# **CX4 Transmit Template Update**

**Dallas, TX  
Mar. 10-13, 2003**

**Steve Dreyer, Intel  
Don Alderrou, Intel  
Schelto vanDoorn, Intel**

# Simulation Results @ TP2, 90nm Process

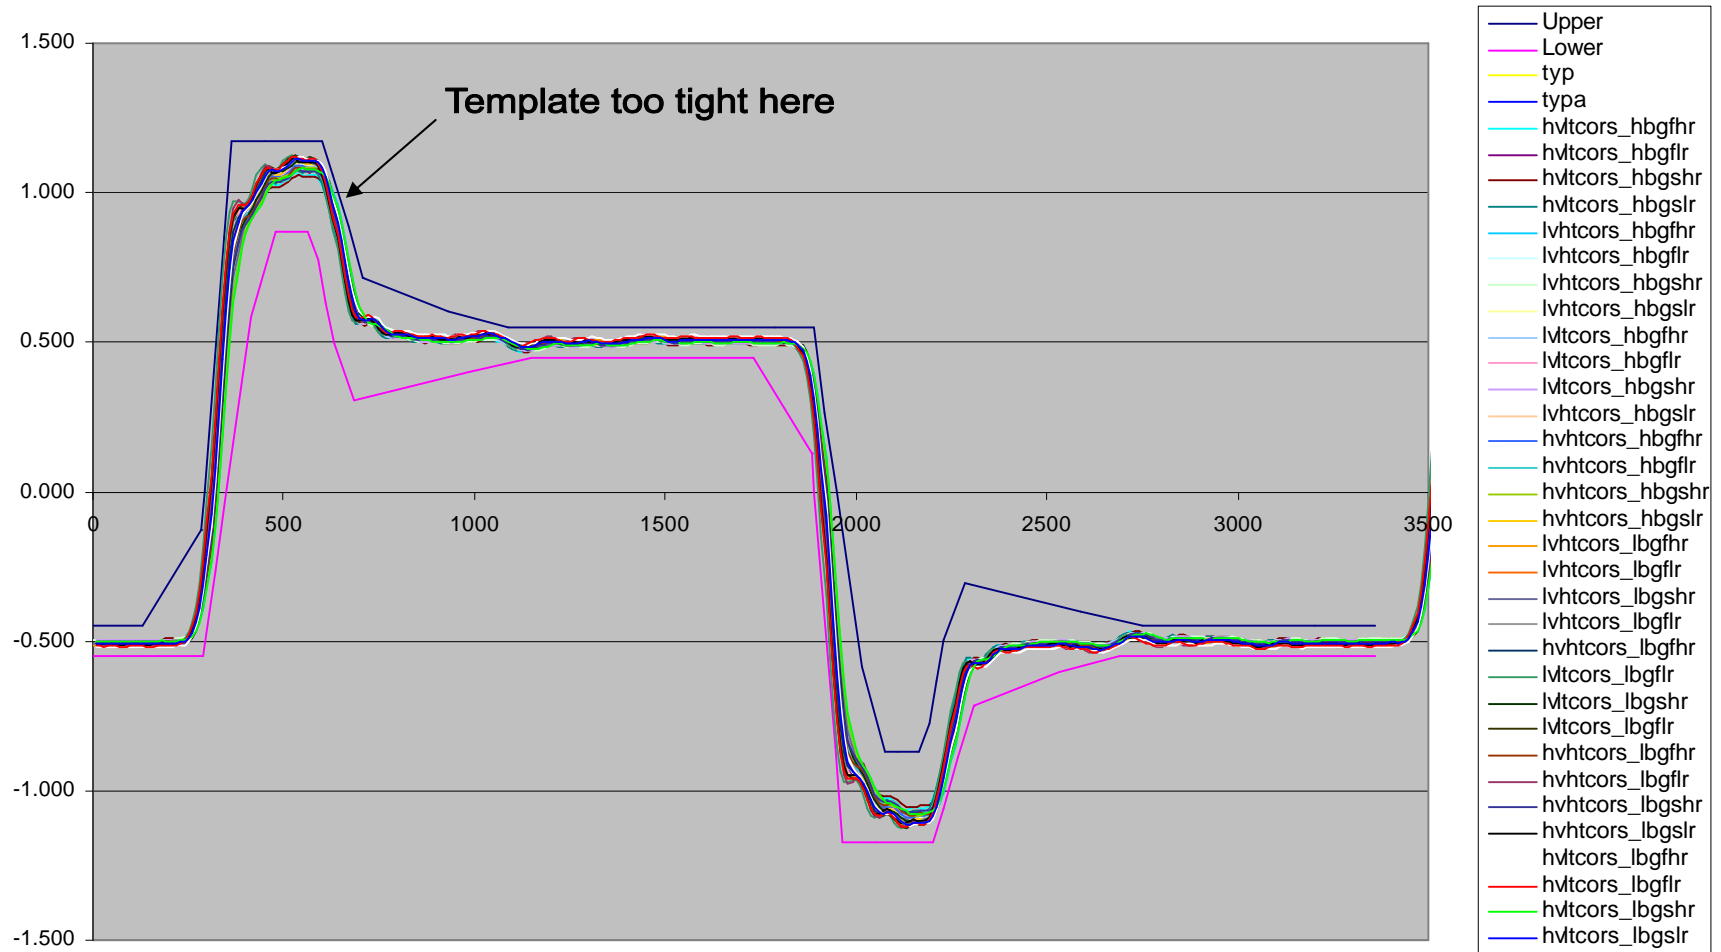
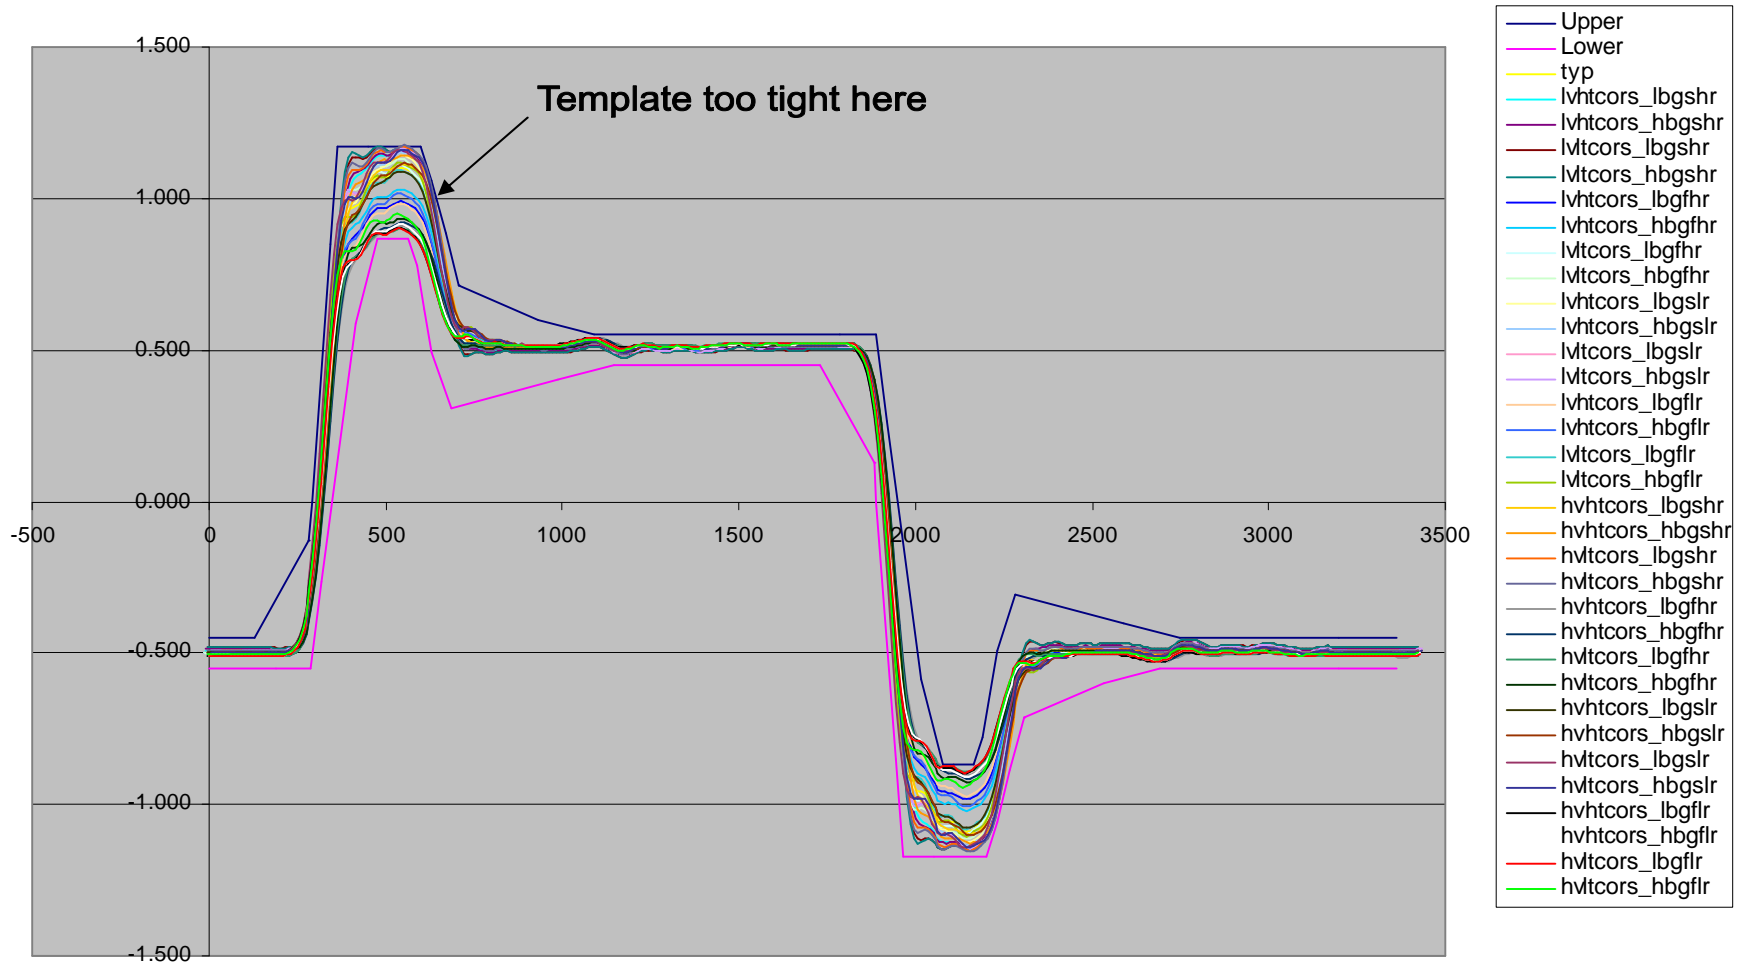
- Conclusions
  - ◆ CX4-WP3.1 template not centered for typical waveforms in ~560ps-710ps region, simulated results very close to upper bound
  - ◆ If four points in CX4-WP3.1 template are moved per P. 6 recommendation, then:
    - Centers template
    - Provides adequate margin for designers
    - Area under the curve changes ~1.3%, effect on far end minimal
    - Consistent with Zeev Roth's proposed template changes
- Proposal
  - ◆ Change template per P. 6.

# Template Centering

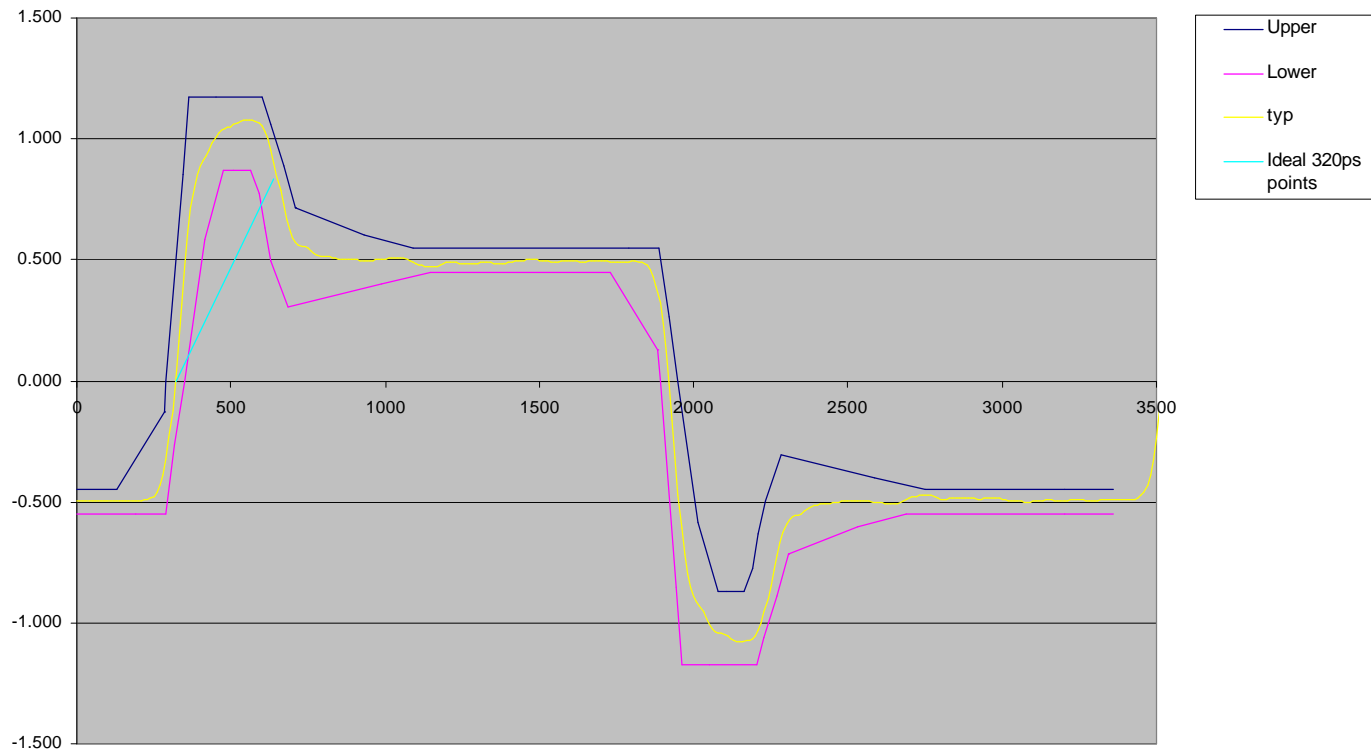
- Below, a line is drawn between  $t=320\text{ps}$  and  $t=640\text{ps}$  ideal points. Typ simulated 90nm waveform also shown.

- Template not centered at  $t=640\text{ps}$
- Even though typ simulated waveform is near ideal time point, it is still too close to template boundary

# Problem & Solution

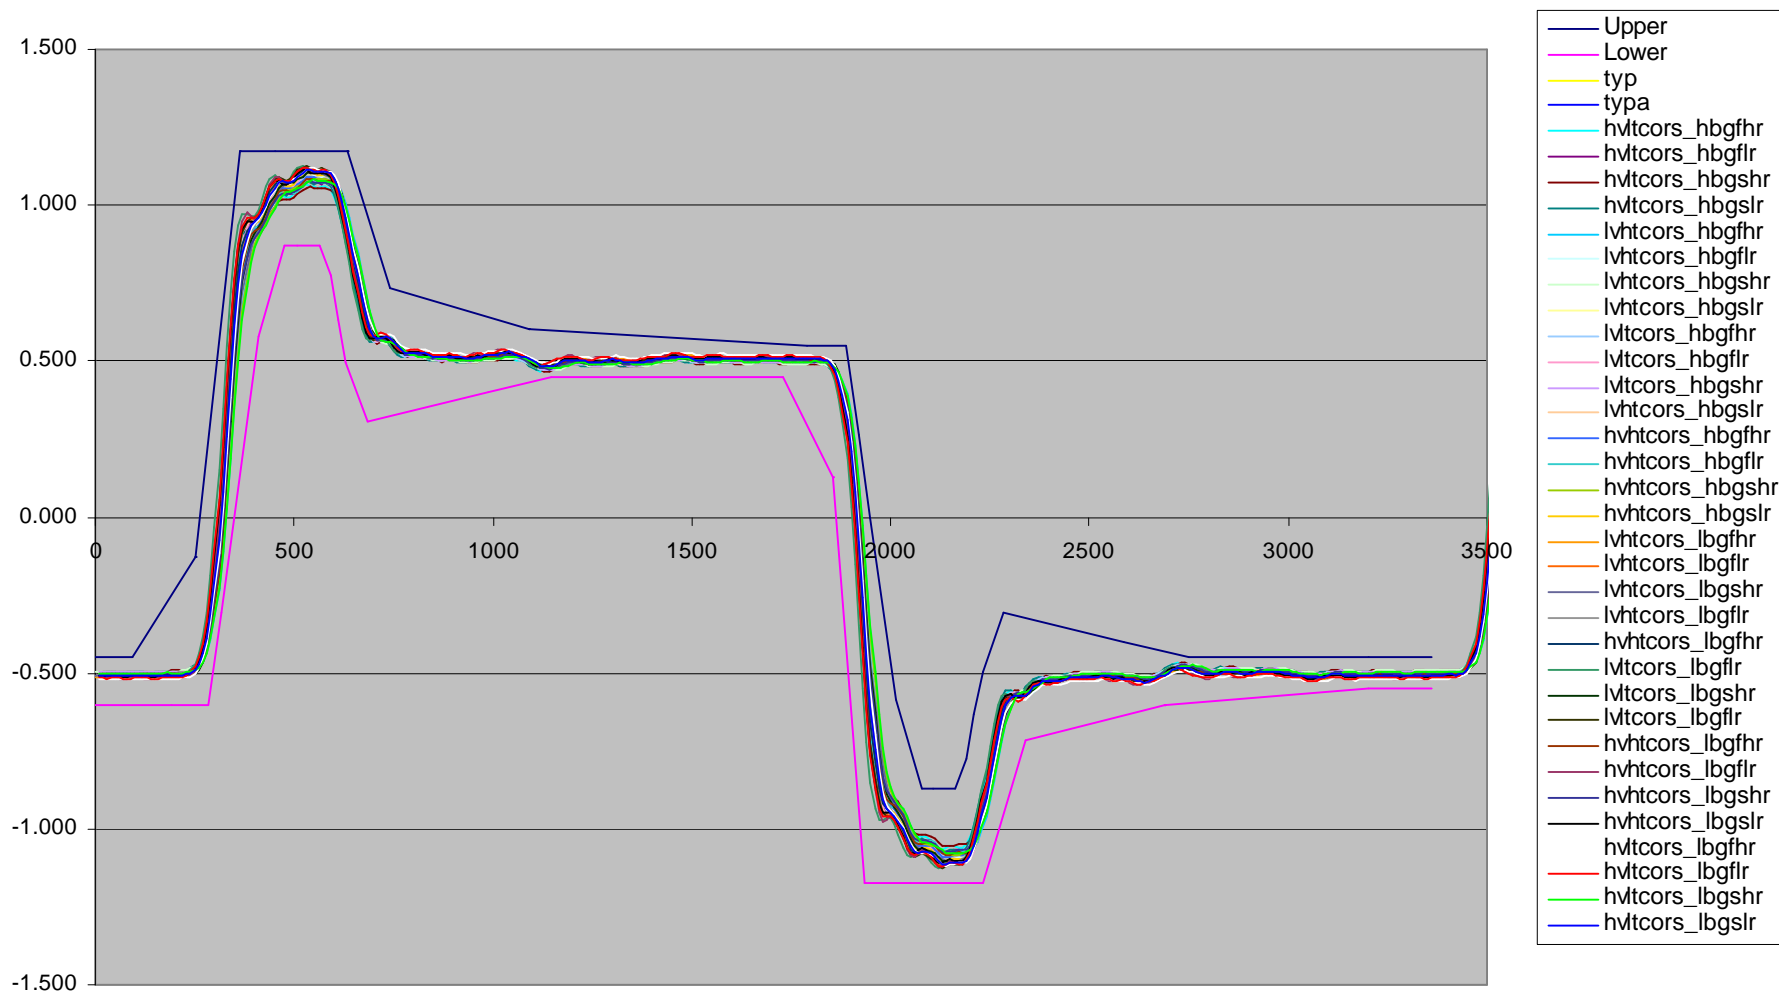
- Problem
  - ◆ On CX4-WP3.1, template not centered for typical waveform in ~560ps-710ps region
  - ◆ Simulated results too close to upper bound
- Solution
  - ◆ Move four upper limit points in 602-709ps region over 30ps as follows:

CX4-WP1 Spec Points		Proposed Spec Points	
602 ps	1.175	632 ps	1.175
629 ps	1.060	659 ps	1.060
669 ps	0.888	699 ps	0.888
709 ps	0.715	739 ps	0.715

- ◆ Do same for bottom half of waveform
- ◆ Now let's do simulations to validate
